Enclosure 2

PPL Response to SRBC letter dated December 21, 2011, including

**PPL RESPONSE TO SRBC COMMENT LETTER DATED DECEMBER 21, 2011****GENERAL PPL RESPONSES:**

Proposed Bell Bend Nuclear Power Plant Site, Luzerne County,  
Pennsylvania

**Figure 5-6a** Average monthly temperatures compared with 2010 temperatures and showing 1 and 2 standard deviations above mean long term (1974 - 2009) averages

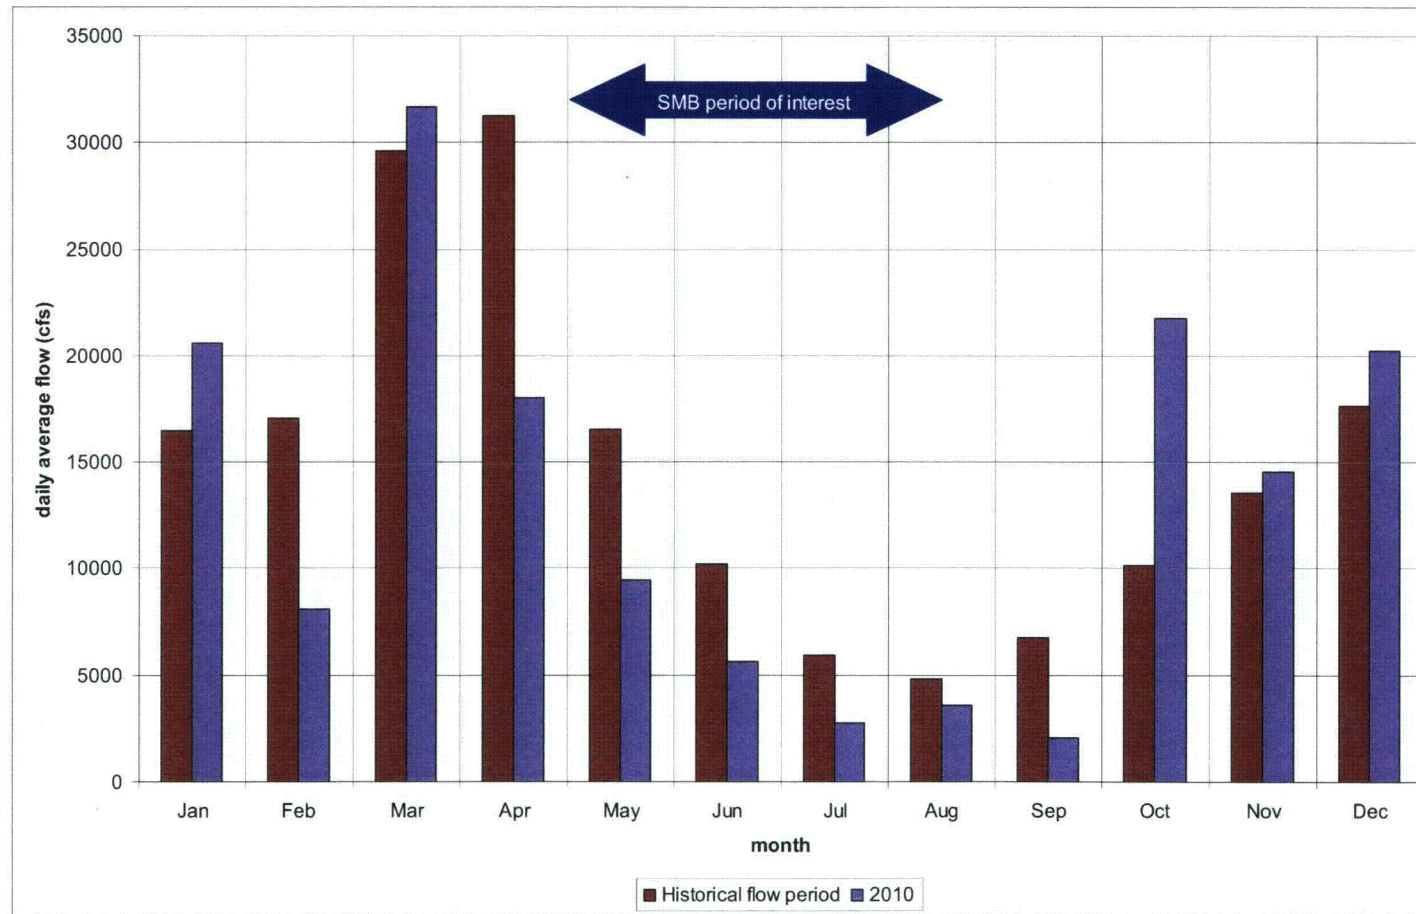
11. (e) *On page 73, the analysis on Figure 5-6 indicates that water temperatures in 2010 were warmer than the historical average. The text should explain the data collection method and location(s) of the temperature recordings. To draw valid comparisons with the 1974 to 2009 time frame, the collection method and location should be consistent. Chaplin et al. (2009) indicates that a difference of 0.8°C in water temperature was noted in 2008 compared to the historical record (1974 to 1979), consistent with warming trends in other parts of the world. Based on this, the data from 2010 also should be compared to the more recent record (2006 to 2009). It should be noted that, if this indicates a warming trend, the impact of the BBNPP consumptive use on SMB in the future will be exacerbated because of the increased stress caused by natural conditions.*

The comment indicated for Figure 5-6 was simply describing observed water temperature for 2010 compared to recent historical information. It was not the intent nor within the scope of this study effort to analyze that data in terms of potential climate change impacts.

**Figure 5-7** Sonde 1 (Goose Island shallow) hourly temperature data (F)

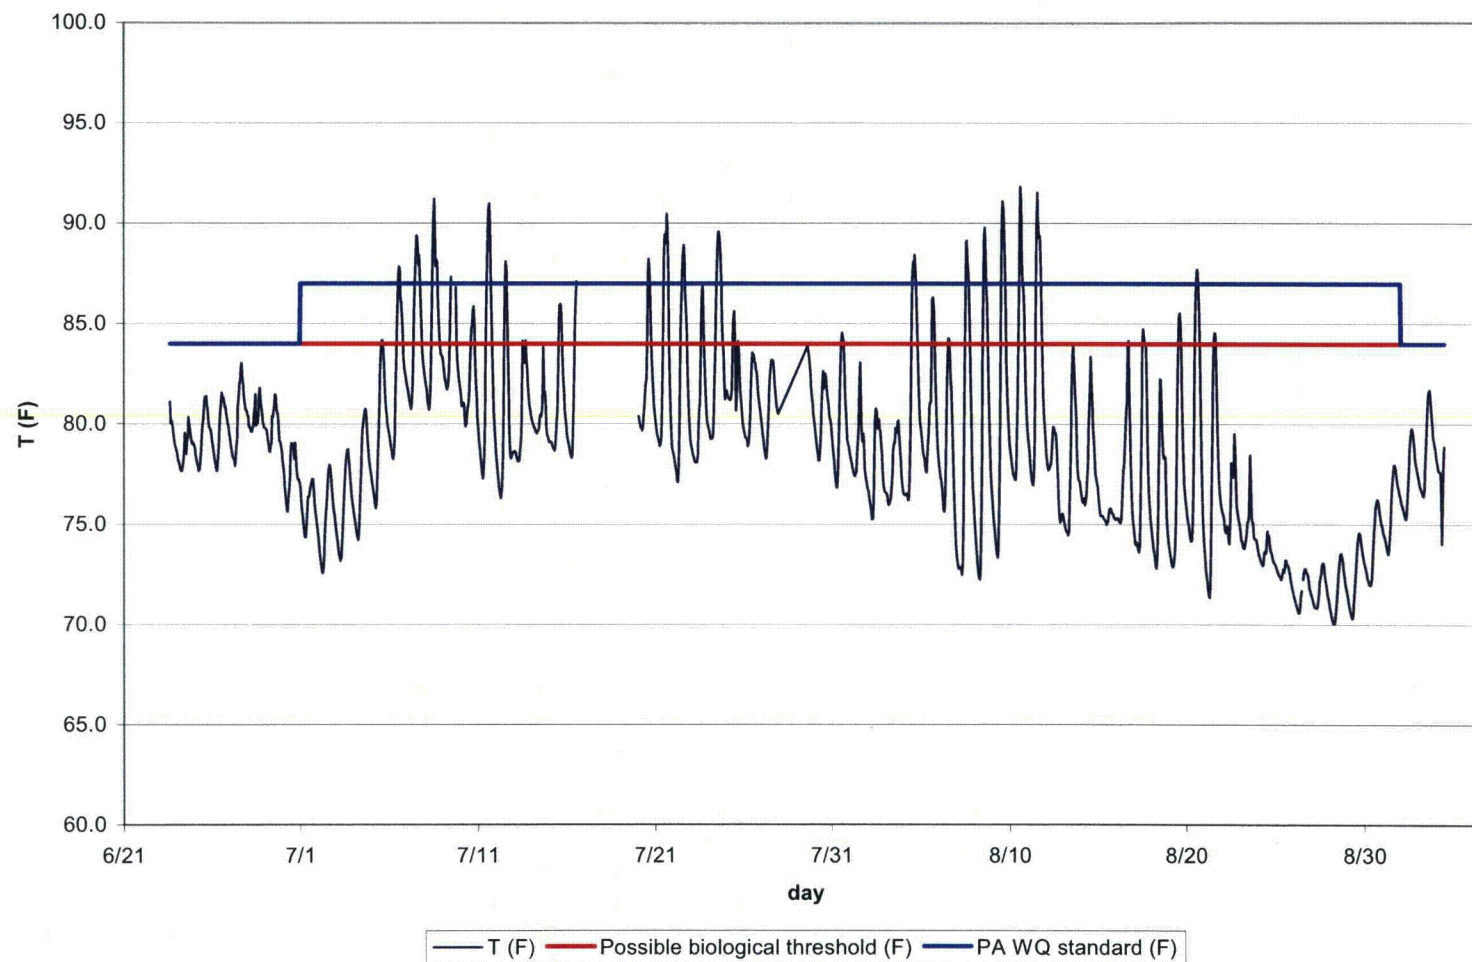
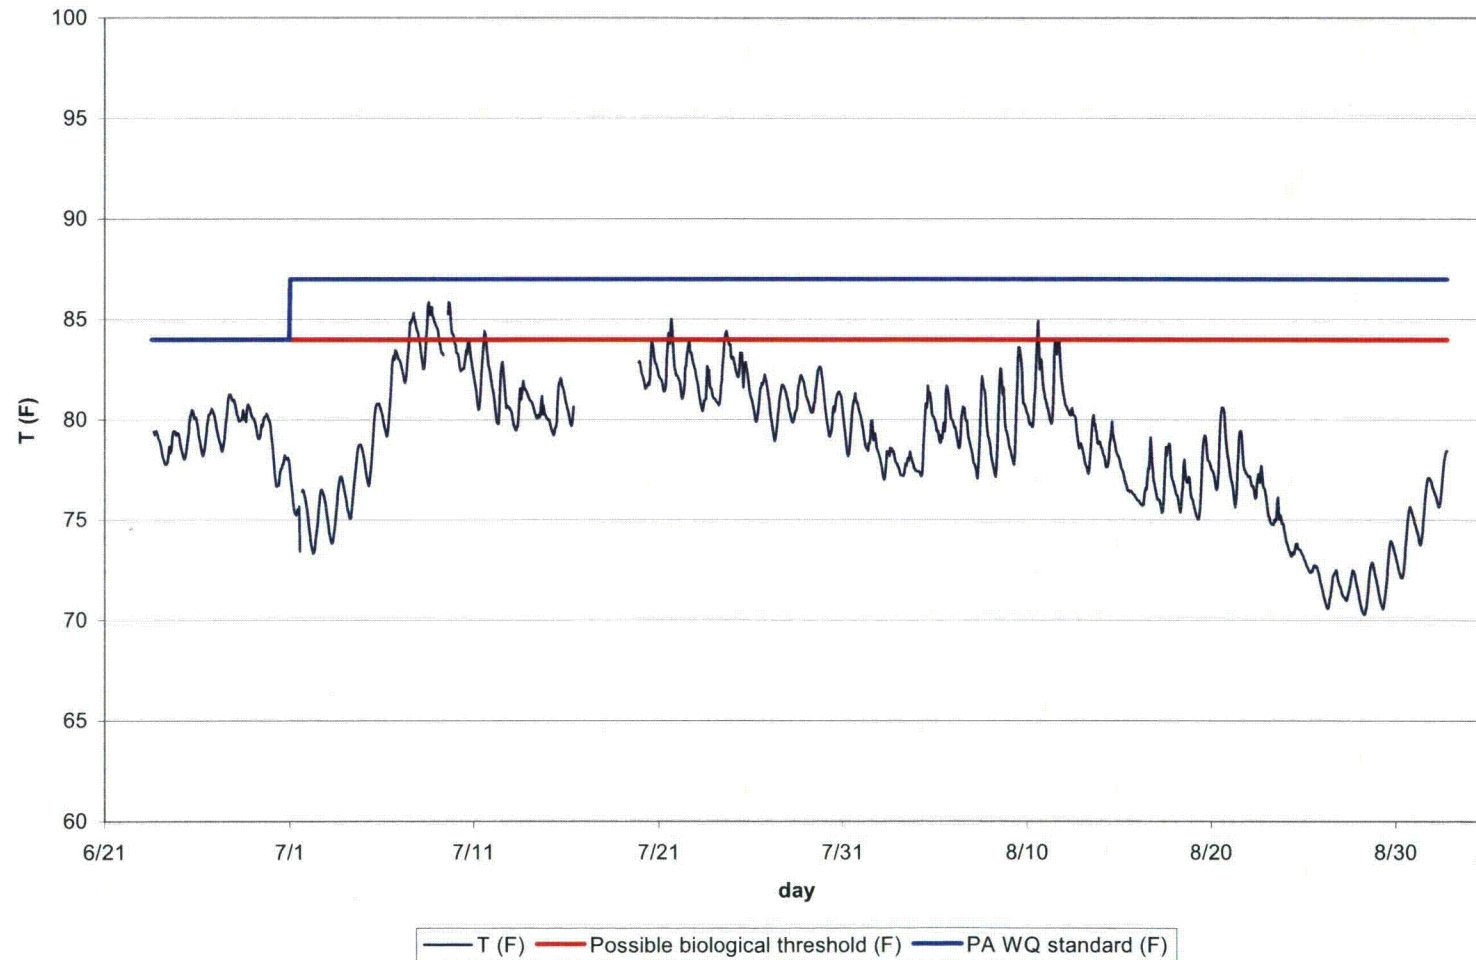
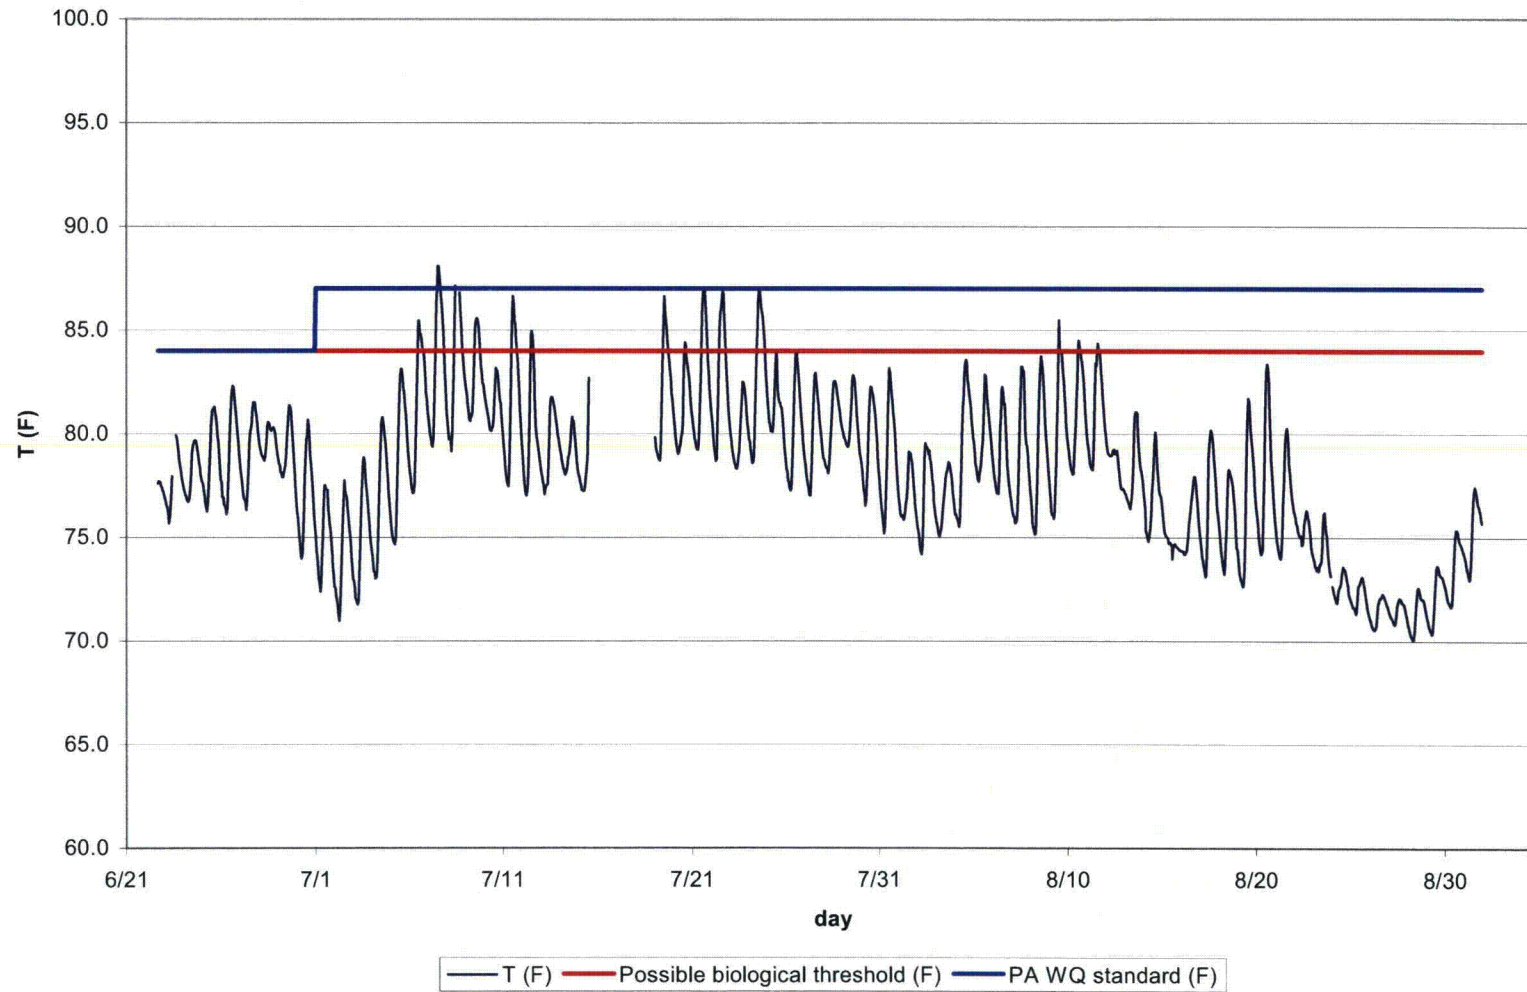
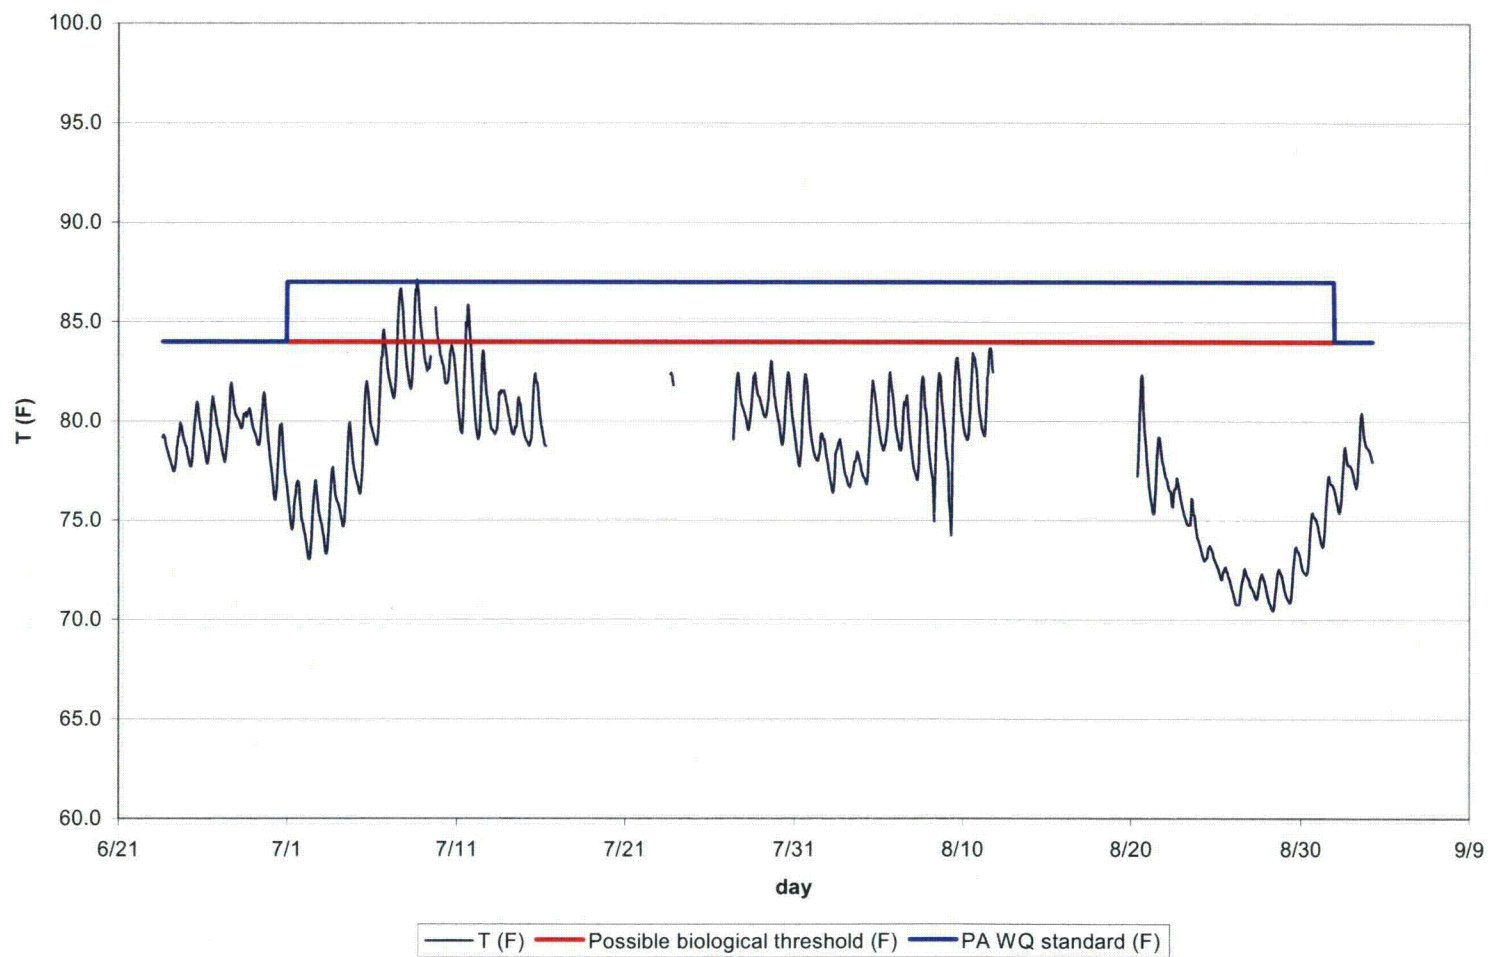
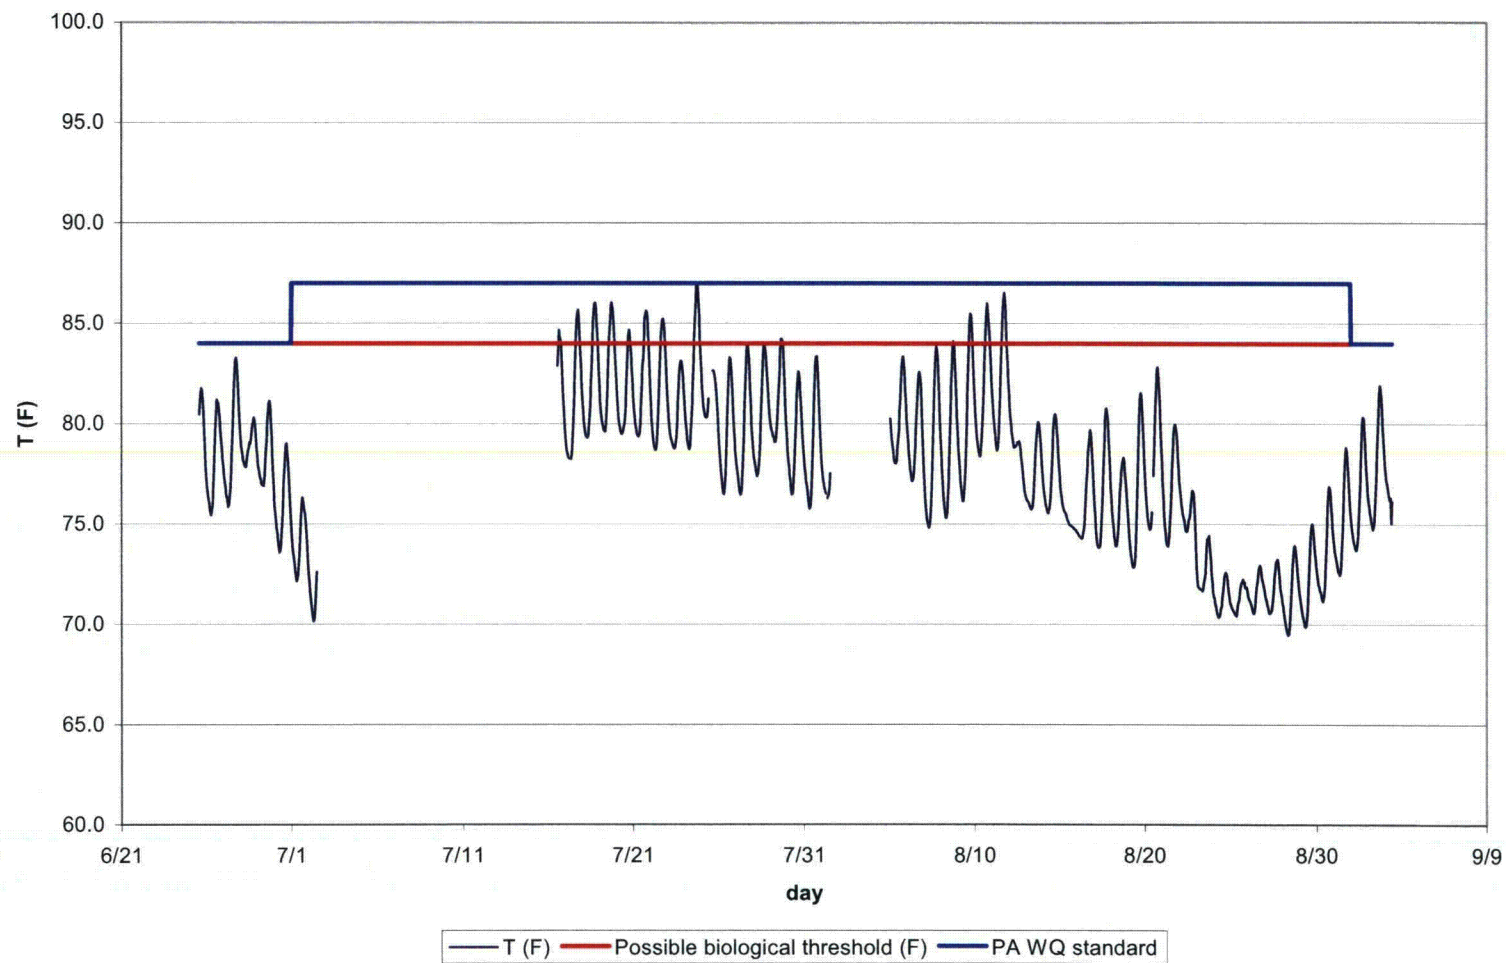
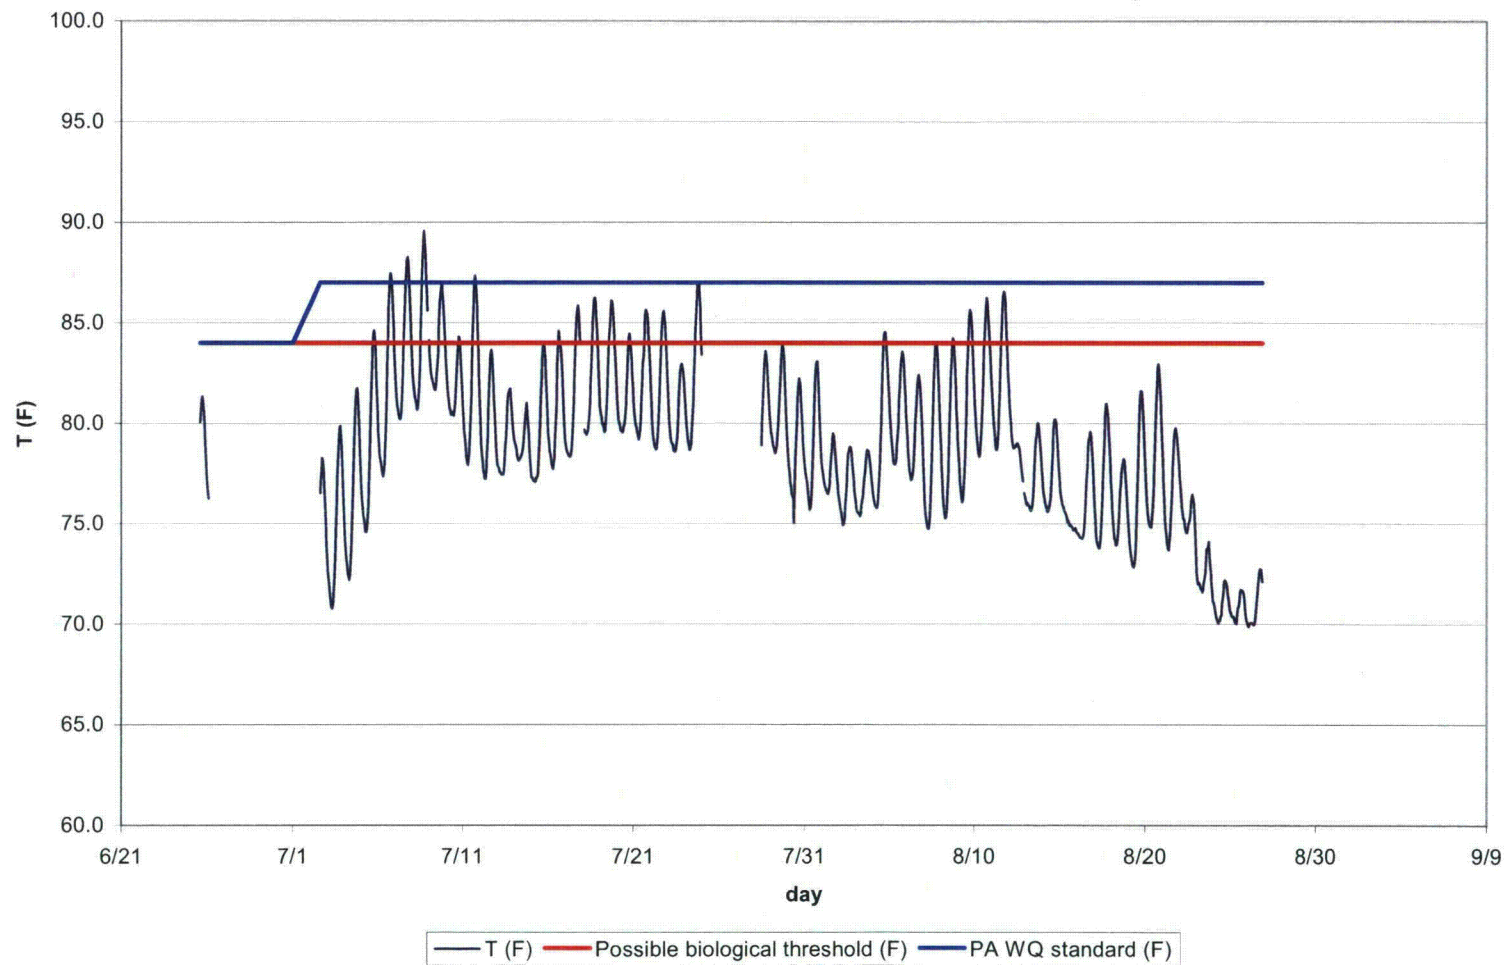
- 12. (f) In Section 5.5.1, Figure 5-7, the figure on the bottom panel of page 76 needs to be resized to be consistent with the other graphs in this section.*

All figures have been revised in the amended report Section 5.

**Figure 5-26 Hours below 4 and 5 mg/l DO and above 4 mg/l for all sondes**

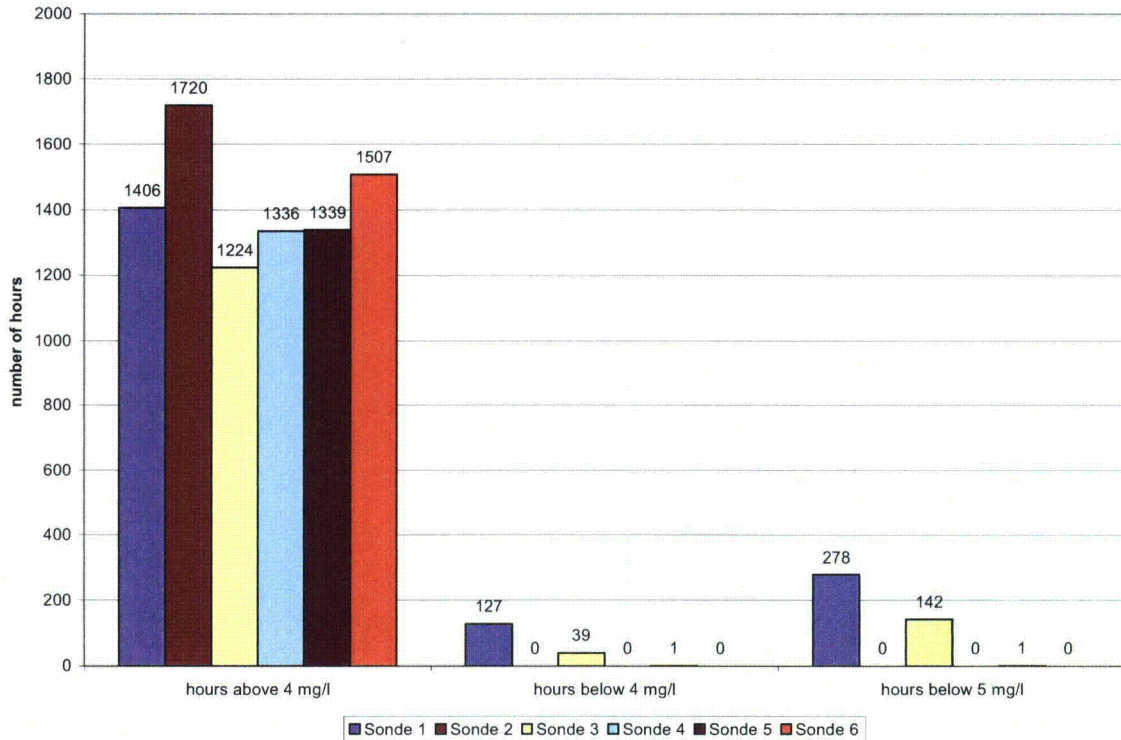
- 12. (i) In Section 5.5.2, Figure 5-10, the July period for Sondes #5 and #6 includes the number of observations above each bar. The other graphs in this section should be consistent with the format used for Sondes #5 and #6.*

The information is provided in Figure 5.26 of the attached amended report Section 5.
